PLANNING DIRECTOR'S SPECIAL PERMIT
1231 "I" STREET, SUITE 200, SACRAMENTO, CA 95814

- APPLICATION:**
- A. Negative Declaration
 - B. Mitigation Monitoring Plan
 - C. Planning Director's Special Permit for a deep lot development for the addition of one unit on 0.25± developed acres in the Standard Single Family Residential (R-1(EA-4)) zone.
 - D. Planning Director's Special Permit for a deep lot development for the addition of two units on 0.31± developed acres in the Standard Single Family Residential (R-1(EA-4)) zone.

LOCATION: 6431 and 6435 Hogan Drive
(Council District 8)

APPLC.NO. P92-151

EXHIBIT C

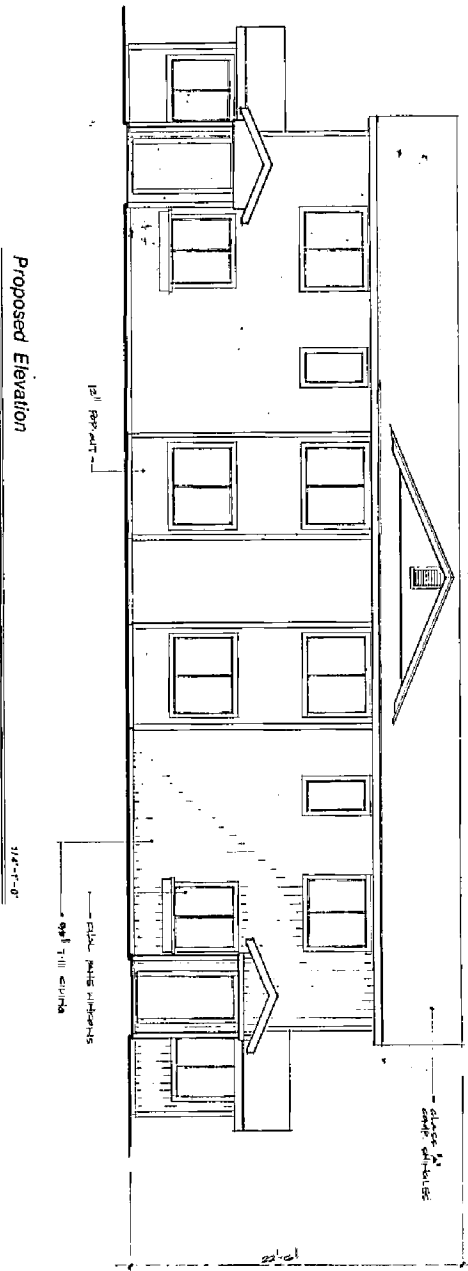
The submitted site plan includes two adjacent properties sharing a driveway. The western parcel has an entrance driveway and the eastern parcel has an exit drive. There is a planter strip in between the two driveways ranging from eight feet to 13 feet wide. There are existing trees within this proposed planter area. There are two parking stalls provided at the end of the driveway for the western parcel containing the proposed duplex, and a two car garage for the eastern parcel with the proposed single family residence.

If the one-way pair of driveways is constructed, a variance approved by the City Council will also be needed. As an option, the applicant could construct one driveway (24' min., 35' max. wide) straddling the property line. In either case, reciprocal access easements are required and some trees may need to be removed if a single driveway is constructed.

- 5. The location and design of the driveways shall be subject to the review and approval of the Traffic Engineer.
- 6. The applicant shall provide a fire sprinkler system per N.F.P.A 13D, 1991 Ed. in the two

EXHIBIT D

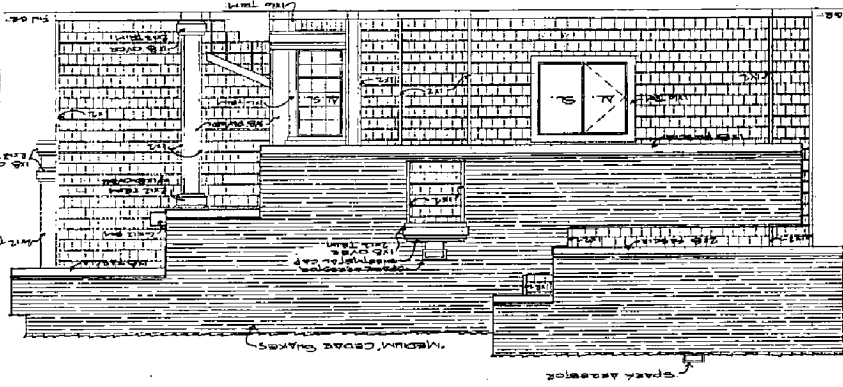
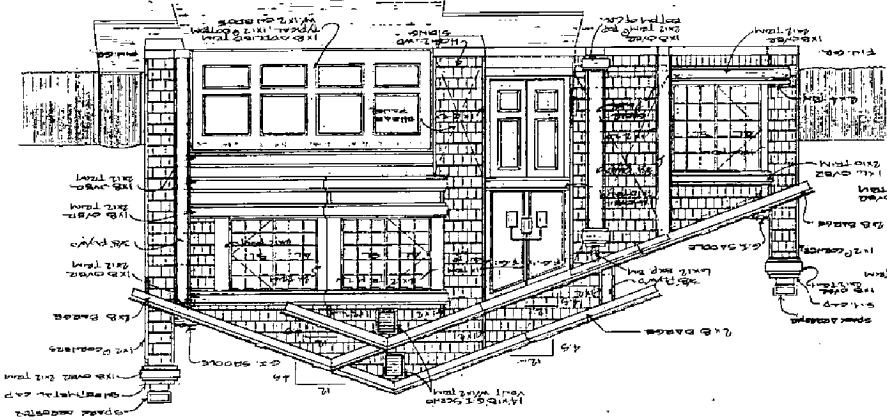
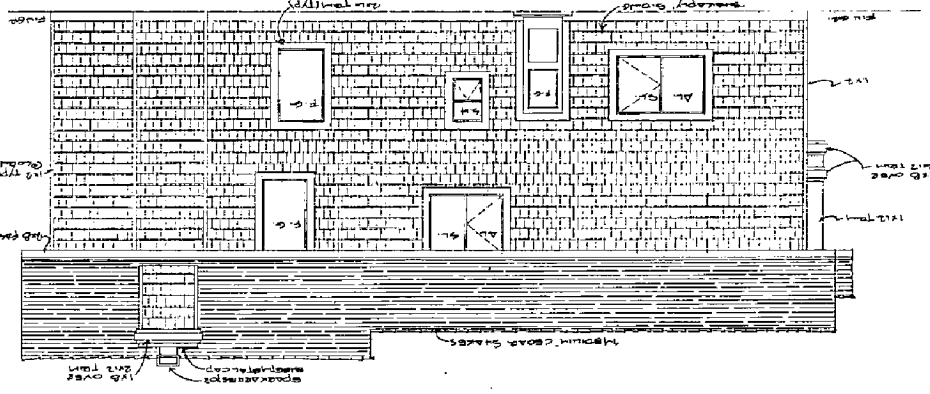
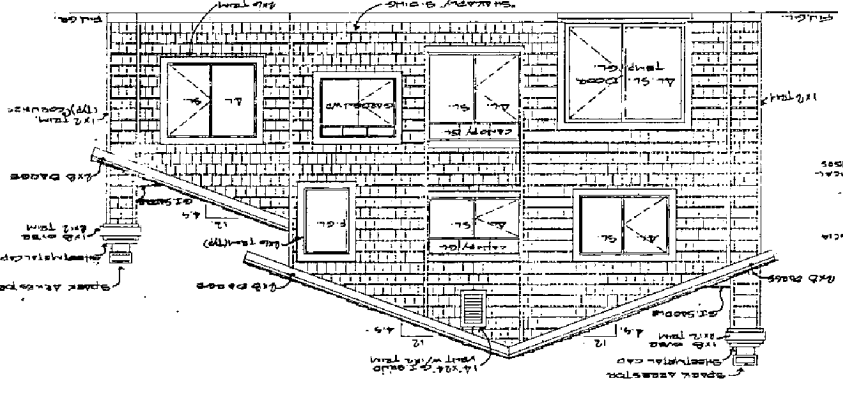
Both the proposed single family residence and the proposed duplex contain two stories. The single family residence contains approximately 2,369 and the duplex contains 2,510 square feet. The proposed materials for the single family residence is "shakaply" siding and a cedar shake roof. The design of the single family residence is an acceptable design. The residence should be developed as per the submitted plans. The exterior materials for the proposed duplex includes T-111 siding with a composition shingle roof. Staff has reviewed the design with a member of the Design Review/Preservation staff and recommends the applicant submit revised elevations which include several modifications. The siding should be board and batten on all four sides to match the existing residence with a horizontal band to divide the first and second floor. The roof material should be laminated dimensional composition shingles. The windows

should be pre-finished dark brown and the front door should contain panels. The elevations include a box-out as indicated on the elevations. This box out is not included on the floor plans. There should also be no roof mounted mechanical equipment for either new building. Revised elevations for the duplex should be submitted for review and approval of the Planning Director prior to the issuance of Building Permits.

- 2. The design of the proposed single family residence shall be as per the submitted plans.
- 3. The applicant shall submit revised elevations for the duplex for review and approval of the Planning Director prior to the issuance of Building Permits. The revised elevations shall include:

- a. The siding shall be board and batten on all four sides to match the existing residence with a horizontal band to divide the first and second floor.

- b. The roof material shall be laminated dimensional composition shingles.
 - c. The widows shall be pre-finished dark brown.
 - d. The front doors shall contain panels.

- e. There shall be a box out as indicated on the elevations. This box out is not included on the floor plans.
- 4. There shall be no roof mounted mechanical equipment for either new building.
